ADDENDUM NUMBER TWO

SOLID WASTE SCALE AND FEE BOOTH RELOCATION

DATE OF ADDENDUM: April 12, 2024

ARCHITECT'S SUPPLEMENTAL INSTRUCTION

ASK 01 Addition of Gutters & Downspout

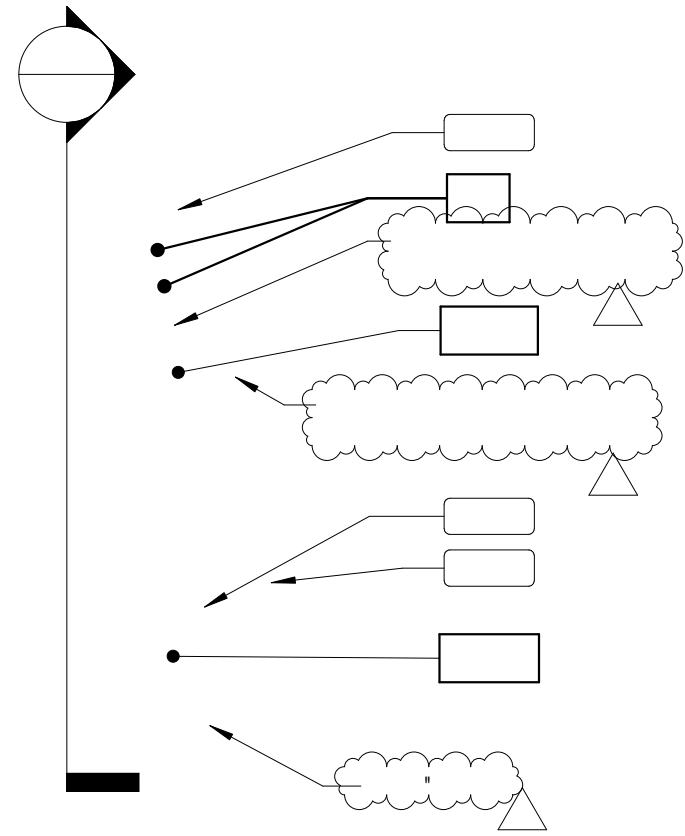
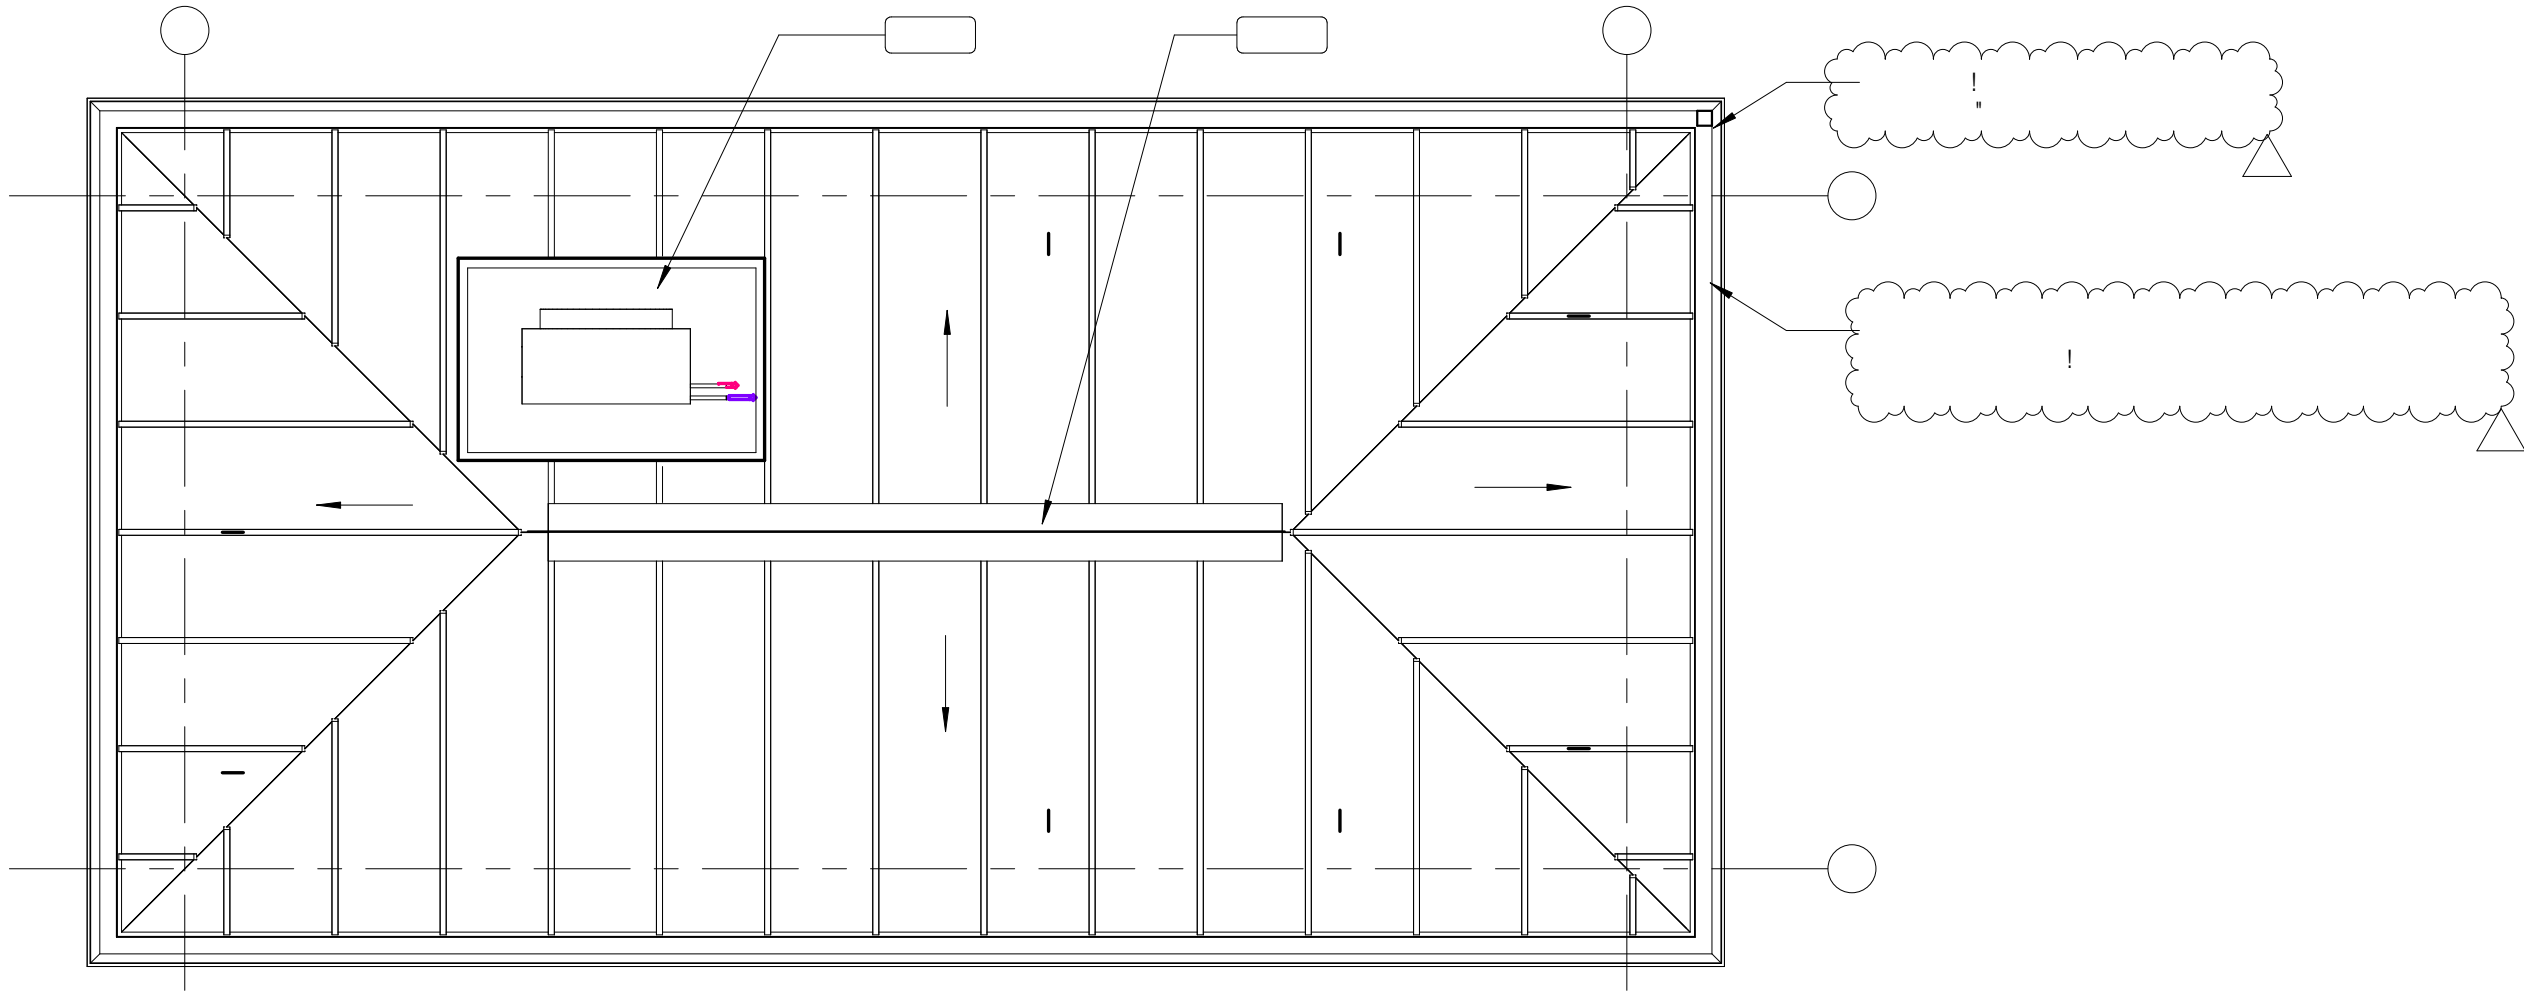
Emailed Question: The Booth structure does not show gutters on it, is this correct?

Gutters and downspout have been added per Owners' request. Gutters shall be integral with the standing seam roof system. Downspout location as show in attached drawing, ASK 01. The contractor shall provide shop drawings for the proposed gutter and roof system for Architect approval.

Response: The fee booth should include gutters and a down spout. This addendum includes an exhibit depicting the updates to include the gutters and down spout.

DWG. NO. 0903 DATE 4/05/24 SHEET NO. 5 OF 52

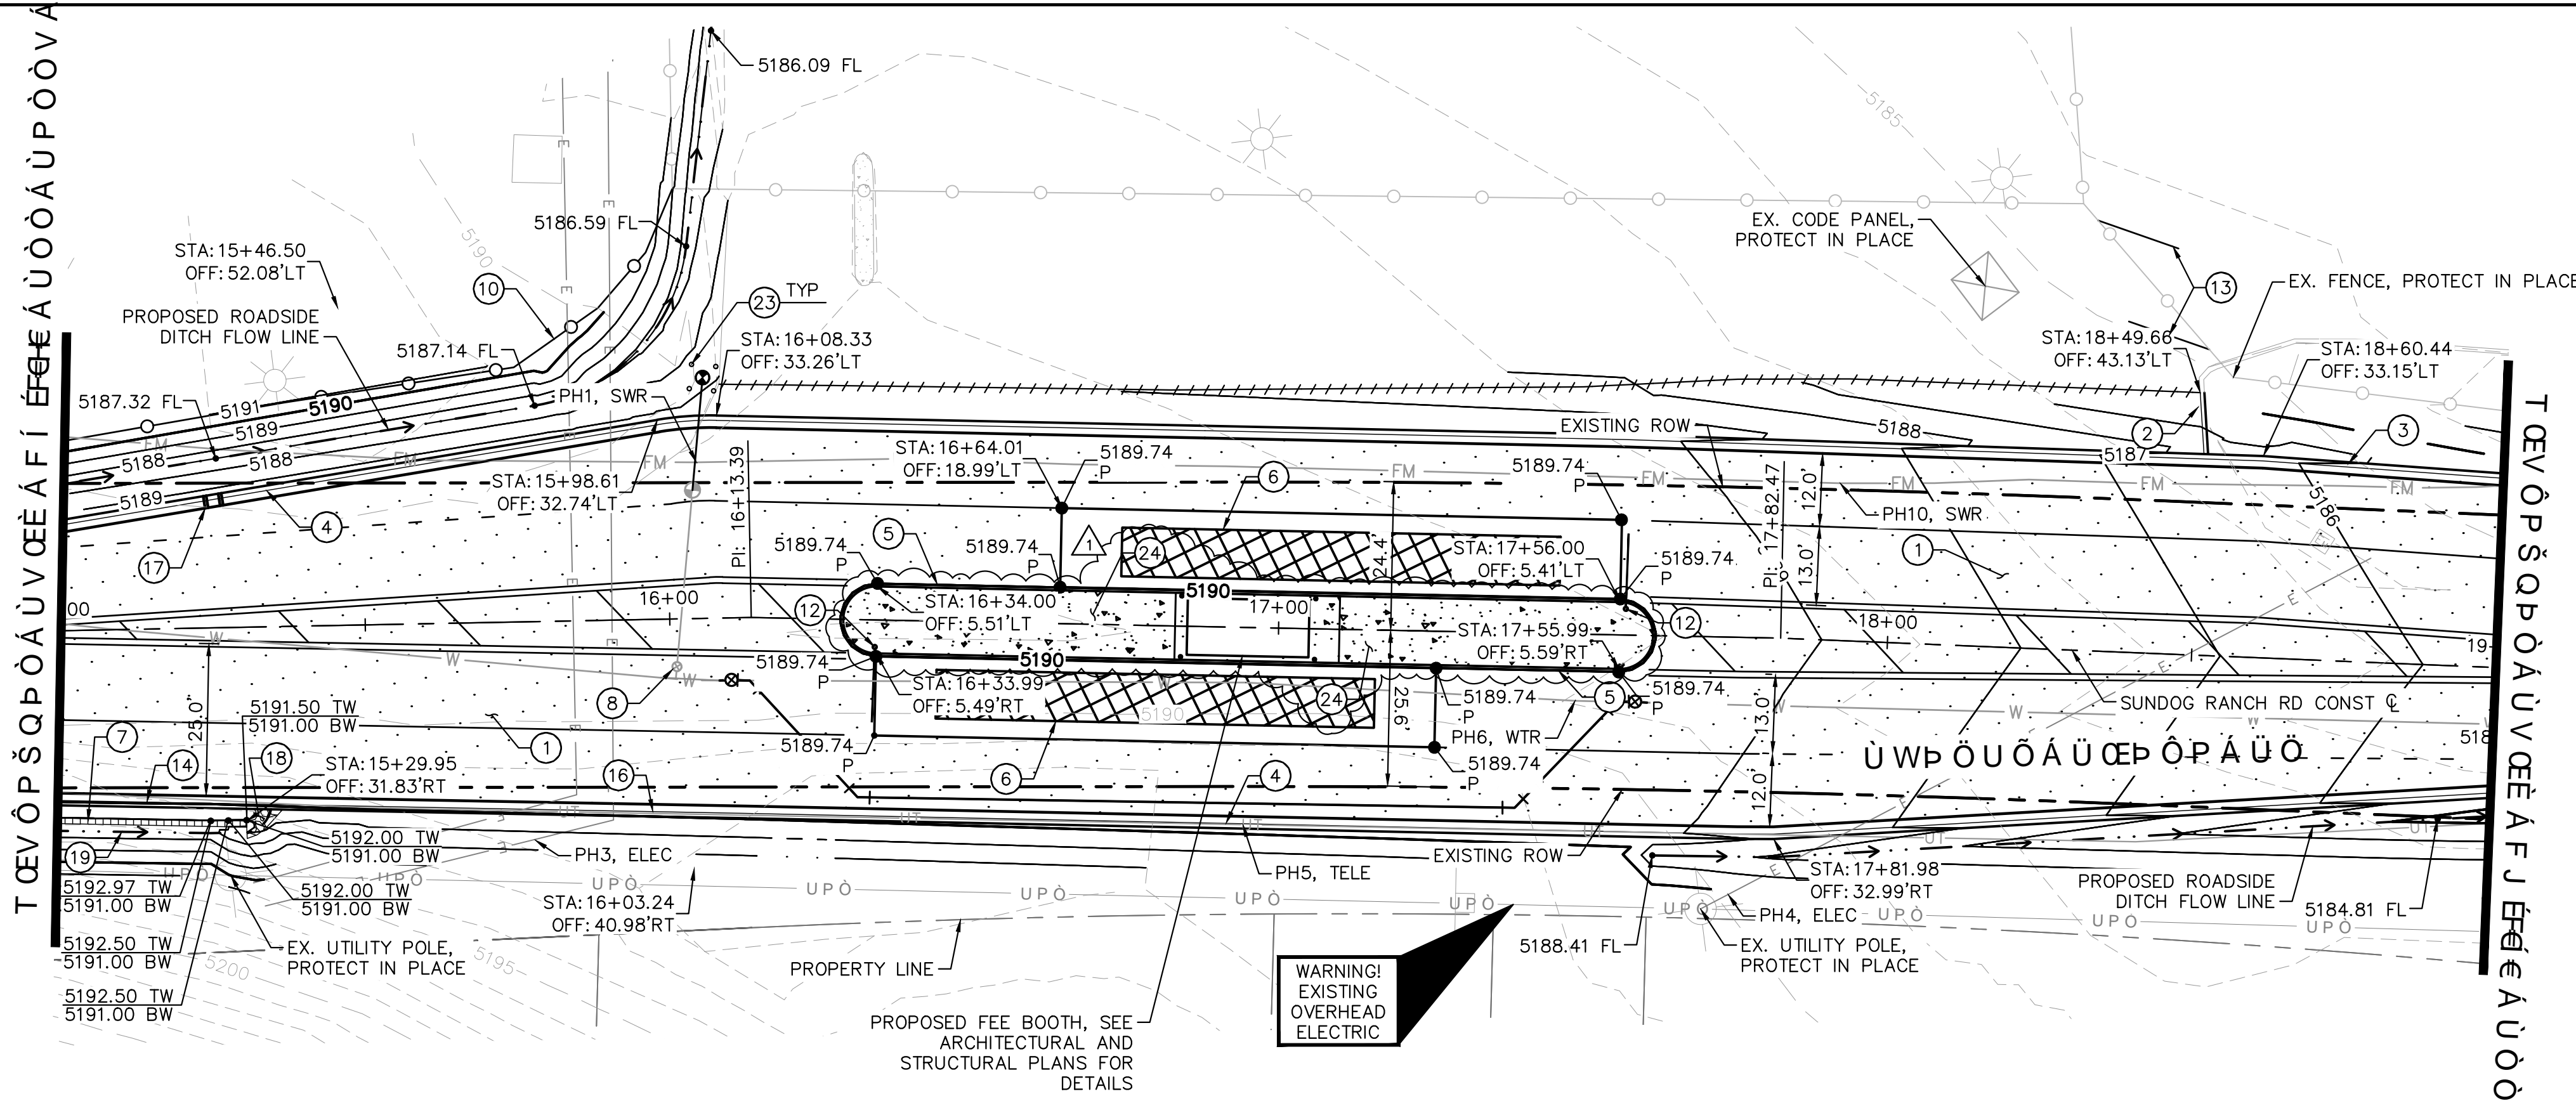
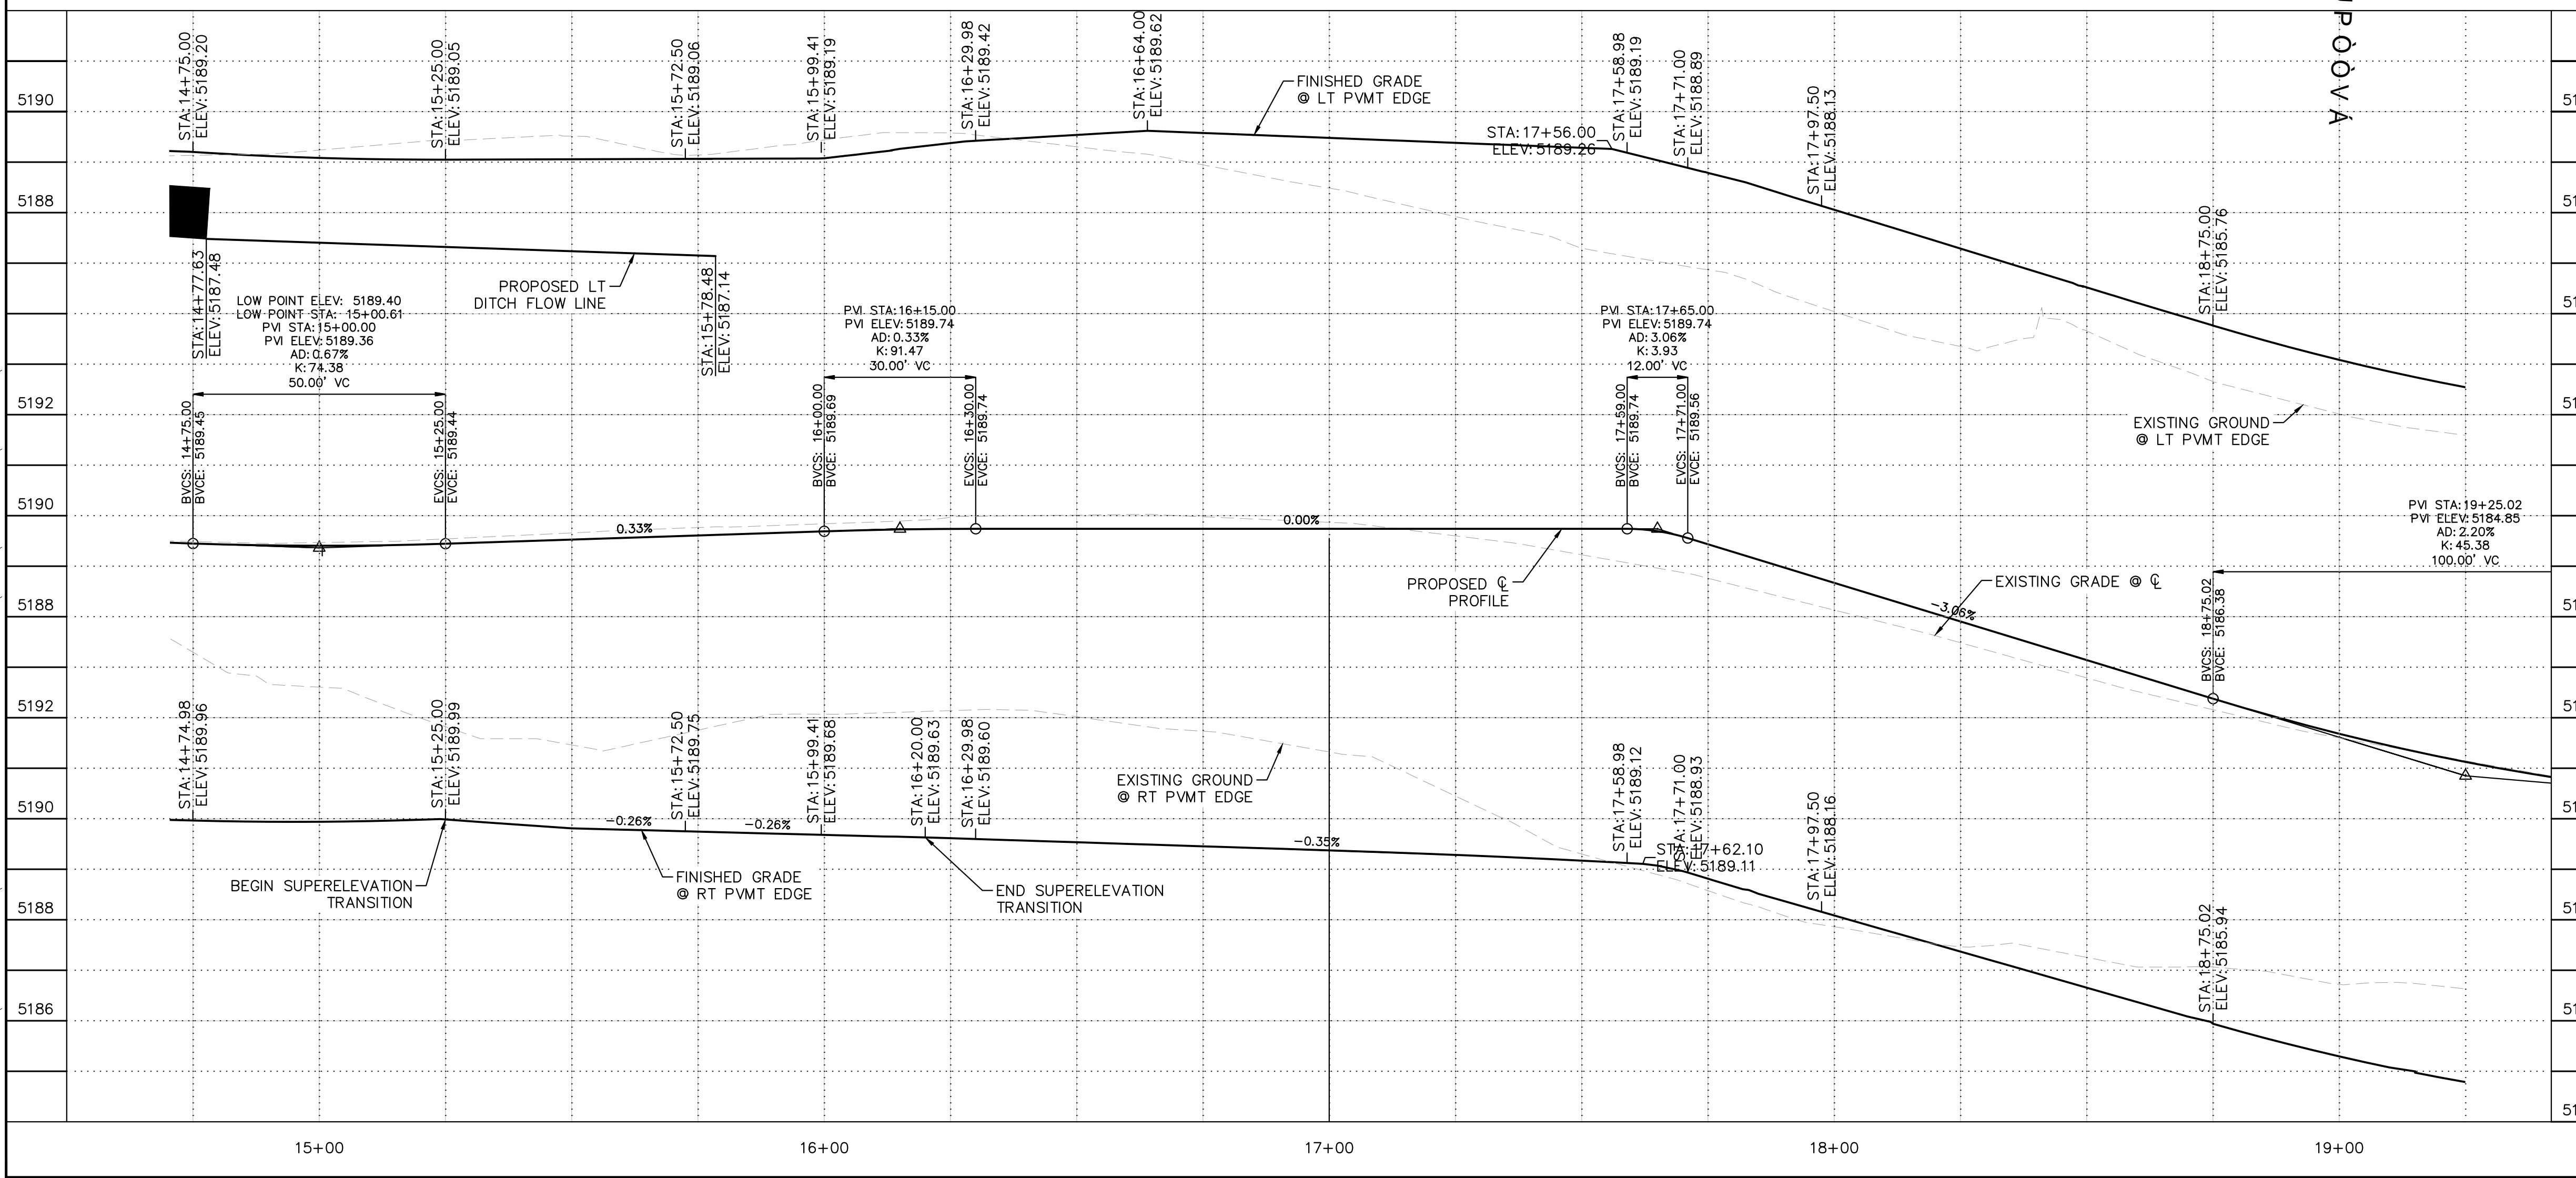
Emailed Question: What type of landscaping is required in the area around the booth structure?

Sheet 14 – Updated concrete limits within the Fee Booth Island.

Response: The entire area around the fee booth has been updated to be 4” concrete. Sheet 14 of the plan set has been revised to depict this change.
